**MASTER DEVELOPMENT DRAINAGE PLAN
FOR
JAYNES PROPERTY**

Please add PCD File No. SKP225

Job No. 1305.02

JAYNES PROPERTY
SKETCH PLAN
MASTER DEVELOPMENT DRAINAGE PLAN
PRE-DEVELOPMENT CONDITIONS

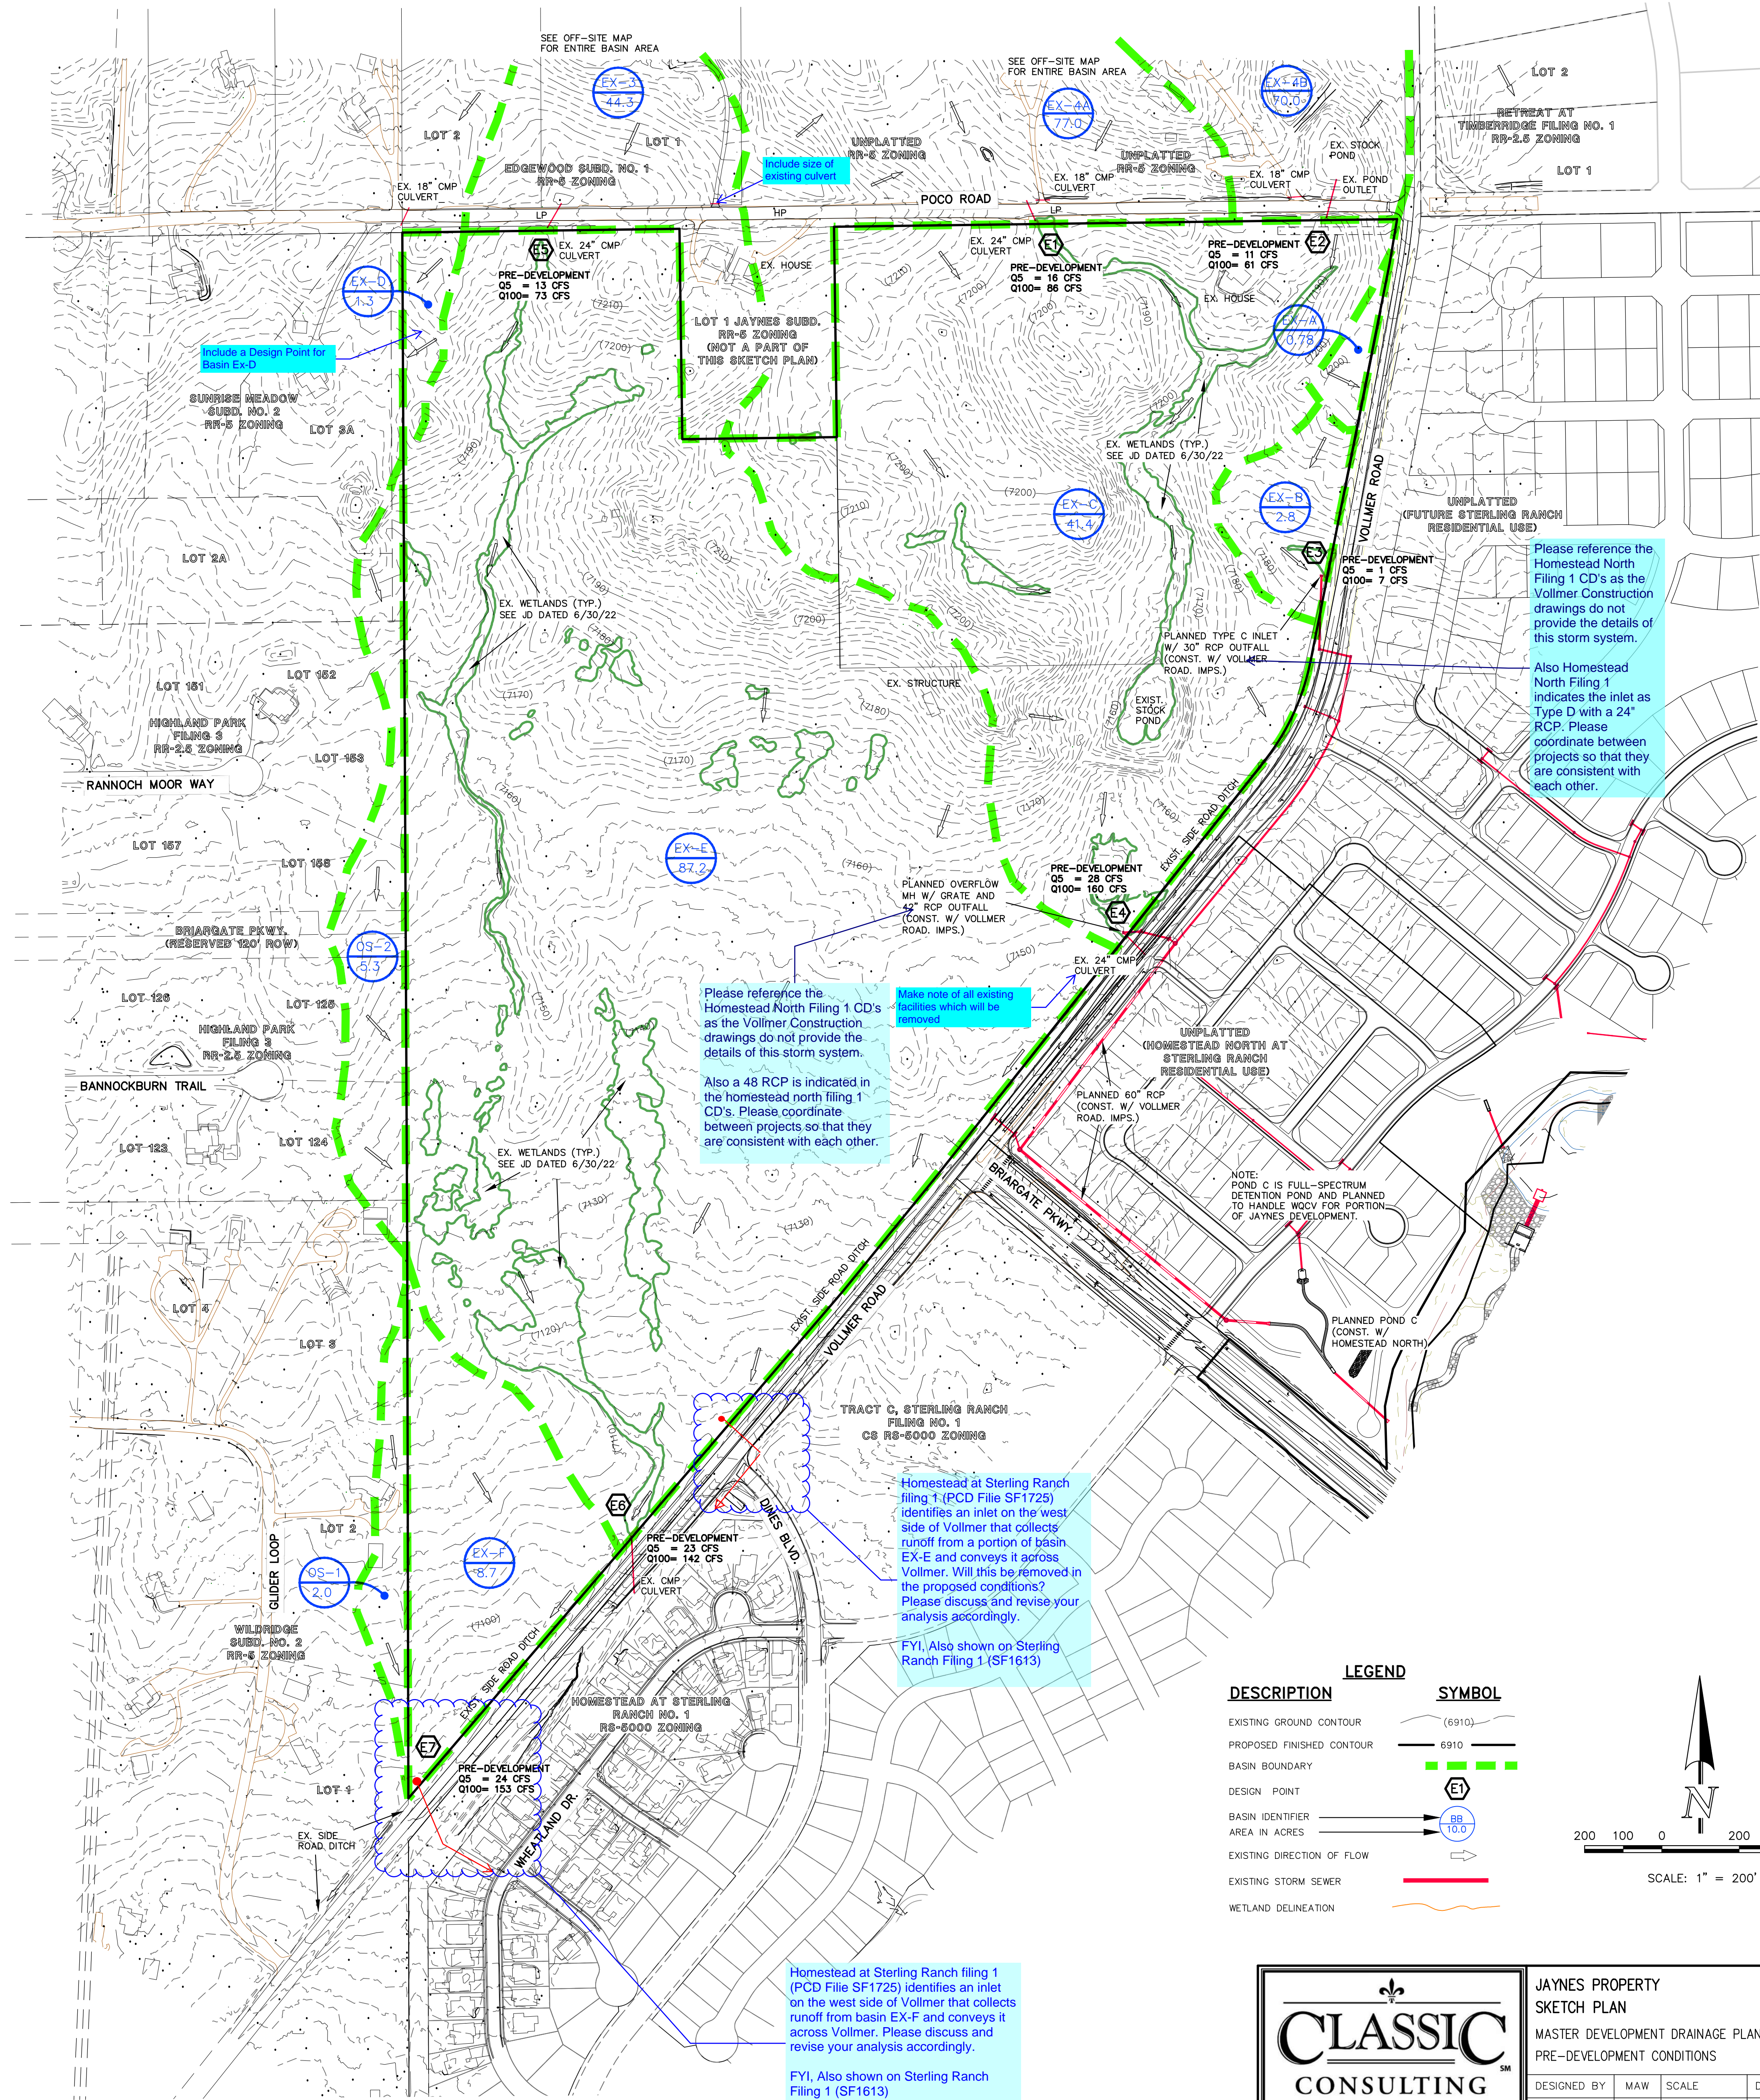
see comments on the drainage plan

Include area for Basin OS-1

Include discussion for Basin EX-D

see comments on the existing drainage plan and address accordingly.

JAYNES PROPERTY
SKETCH PLAN
MASTER DEVELOPMENT DRAINAGE PLAN
DEVELOPED CONDITIONS

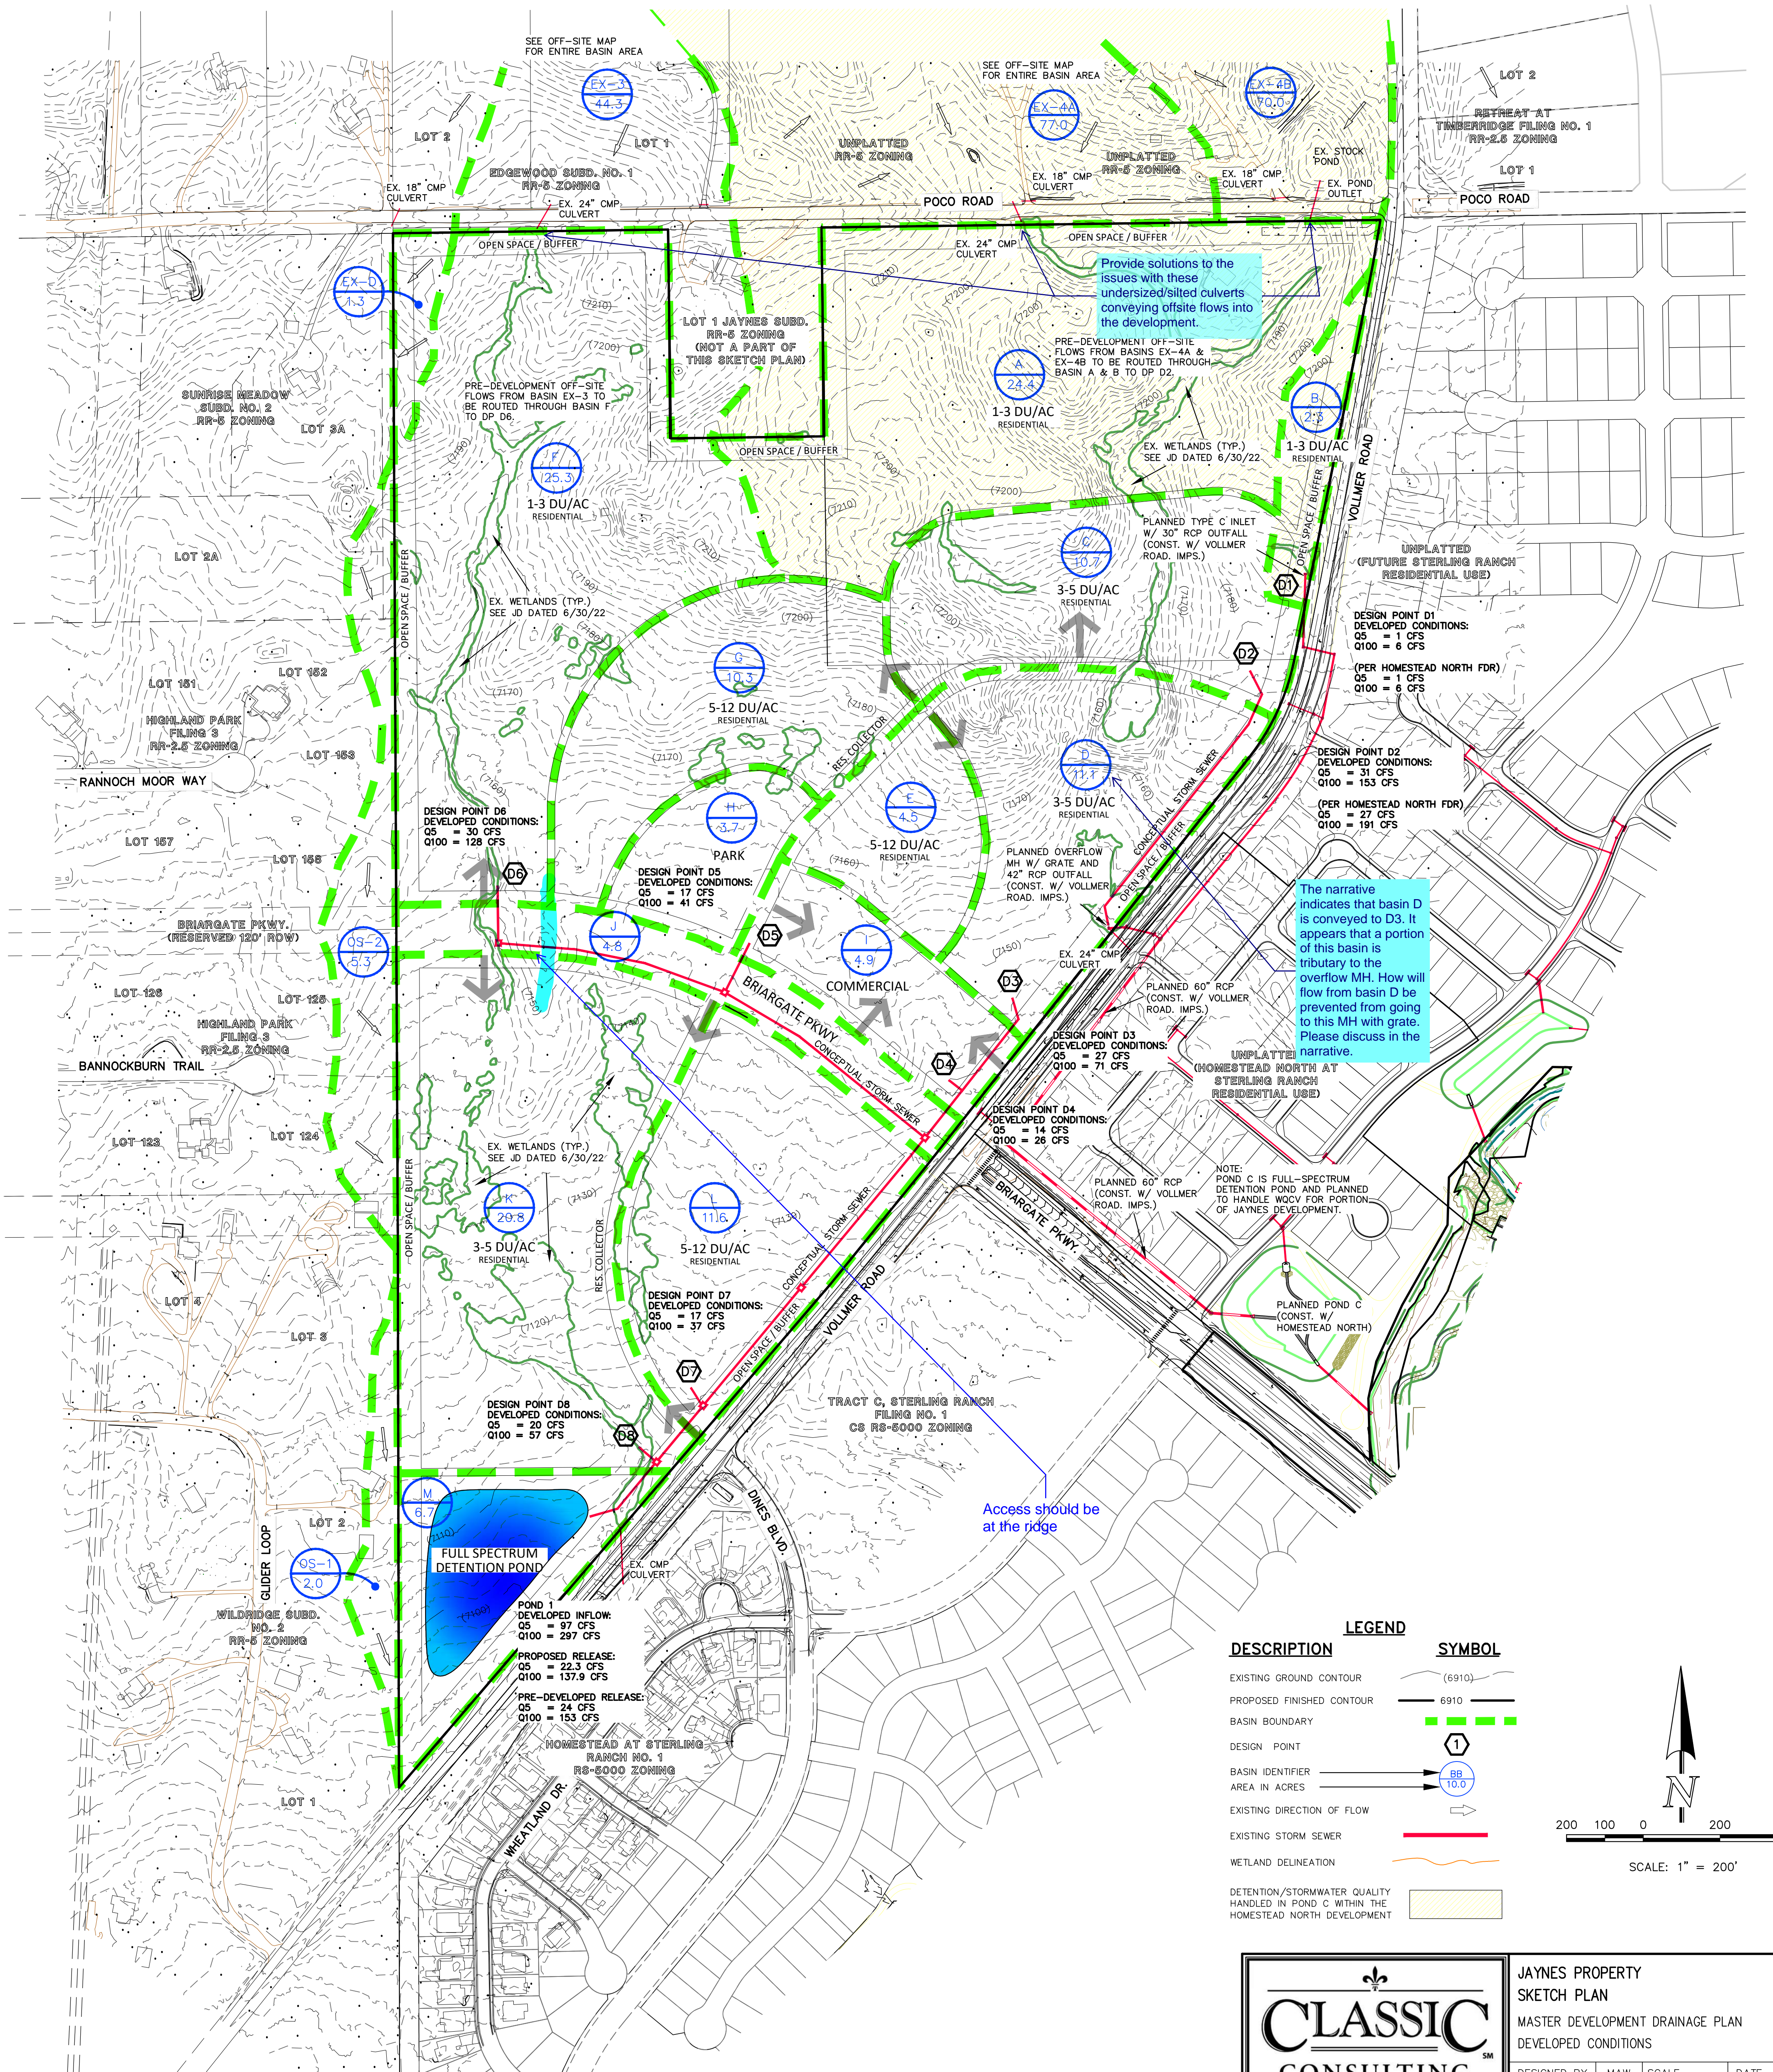
see previous comments regarding this inlet and revise as necessary.

Should be Pond C as indicated on the drainage plan

identify the outfall for Pond C
